DEVELOPMENT ASSESSMENT PANEL REPORT	
Application No.	MOD/2025/0095
Address	246 - 248 Wardell Road MARRICKVILLE
Proposal	Section 4.55(2) Modification to DA/2021/0855 dated 10 May 2022, modification involves addition of three units to the approved shop top housing development, adjustments to wall, core set out and unit layouts.
Date of Lodgement	3 April 2025
Applicant	Mark Beauman
Owner	Wardell 246 Pty Ltd Fabrizia Sons Pty Ltd
Number of Submissions	Two (2) Submissions
Cost of works	\$28,647,567.00
Reason for determination at Planning Panel	Development to which <i>SEPP (Housing) 2021</i> - Chapter 4 Design of Residential Apartment Development applies
Key Considerations	<ul style="list-style-type: none"> • Section 4.3 – Height of Building Variation <ul style="list-style-type: none"> ○ Further variation from what was previously approved under MOD/2023/0019 • Section 4.4 – Floor Space Ratio Variation • Matters raised in submissions

Recommendation	Approved with Conditions
Attachment A	Recommended Amendments to Conditions of Consent
Attachment B	Plans of Proposed Development
Attachment C	Plans of approved MOD/2023/0019

This report is an assessment of the application submitted to Council

Drawing Title
LEVEL 06

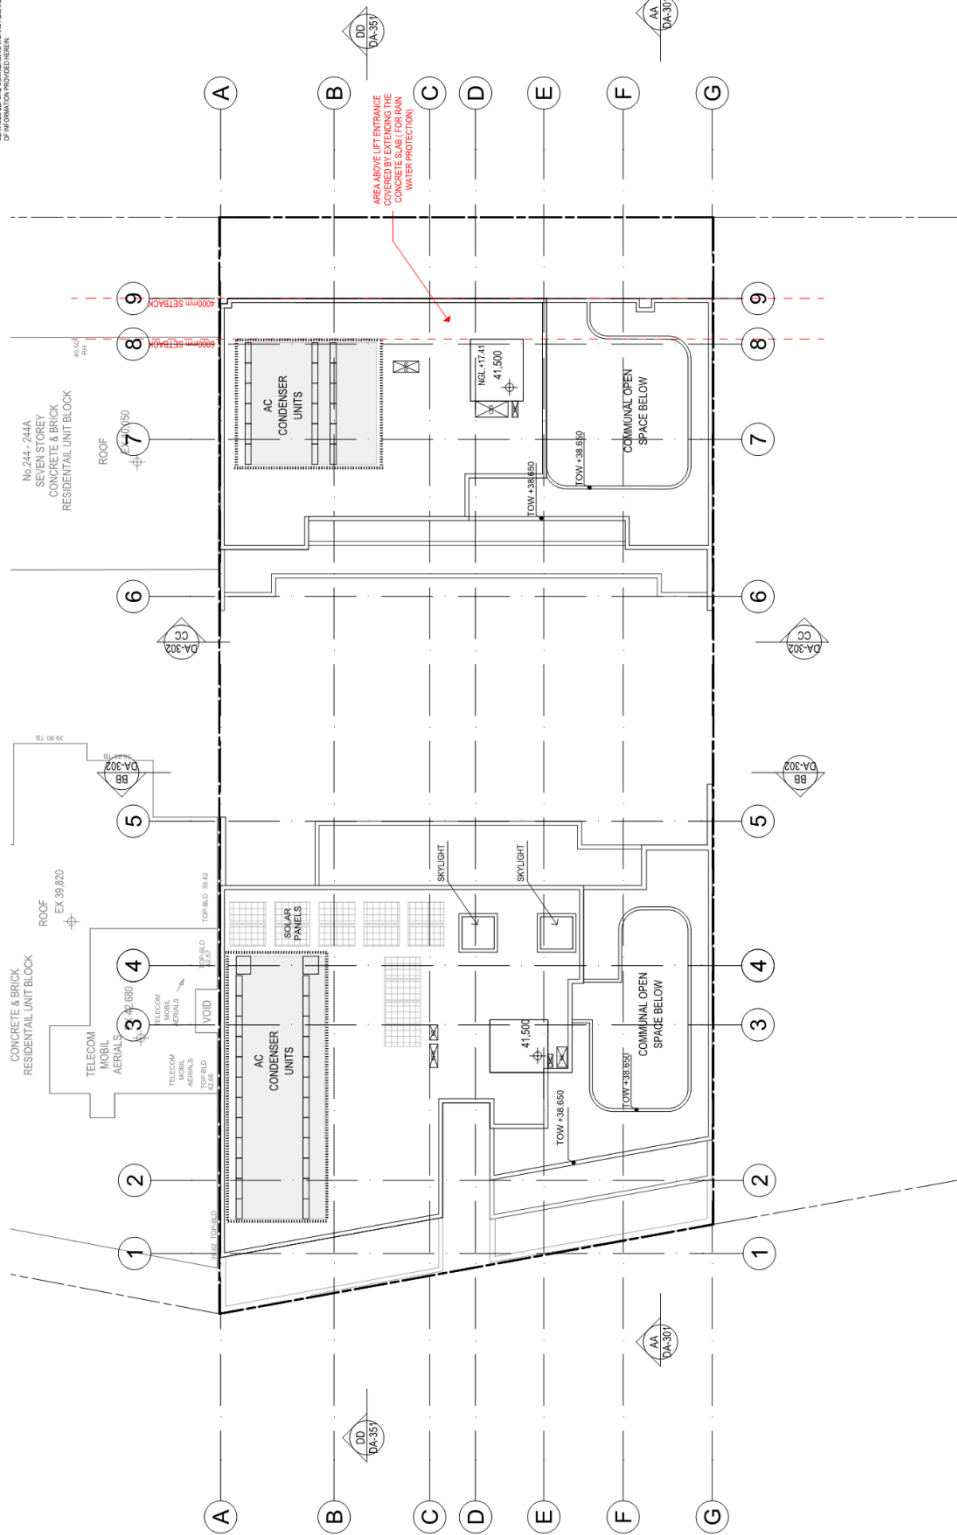
Comment: The modified development complies with the abovementioned requirements as an 18m building separation is proposed between Building A and Building B on Level 6. Further, an adequate separation is provided between the rear adjoining properties to Murray Lane and front adjoining properties to Wardell Road (i.e., more than 9m).

Comment: A minimum two (2) hours solar access is received to the main living room glazing and private open space area of the two (2) bedroom non-adaptable and adaptable units proposed on Level 6 during the Winter Solstice.

Comment: The proposed development complies with the abovementioned relevant requirements and in most cases exceeds the minimum apartment size or dimension. However, the two (2) bedroom non-adaptable unit does have an 8.1m room depth to the open plan living, dining and kitchen room to a portion of this space. Given that this is due to the fact the external wall / window is angled and is only a portion of the space, which accommodates the kitchen bench and television, is technically non-compliant (i.e., 5.3sqm), it is considered that the amenity impact will be minimal; and therefore, the variation is supported in this instance.

Comment: The one (1) bedroom unit and the two (2) bedroom non-adaptable unit to Level 6 comply with the minimum storage requirements under Part 4G – Storage of the ADG. However, the two (2) bedroom adaptable unit has a storage shortfall of 4m³ which varies the abovementioned provisions by 4m³. The variation is acceptable given that additional cupboards may impact the feasibility of the adaptable unit (i.e., turning circles or paths of travel associated with a wheelchair).

- The skylights proposed to the one (1) bedroom unit on Level 6 should be operable in order to maximise natural cross ventilation benefits. A condition of consent is included in the recommendation to this effect. Refer to Attachment A – Recommended Amendments to Conditions of Consent for the correct wording of this condition; and

- b. The soil depth for planters containing trees must be 800mm (excluding drainage cells).
- c. **The skylights to the one (1) bedroom unit on Level 6 (L6.02) are to be operable.**
- d. **Ceiling fans are to be provided to each residential unit on-site.**
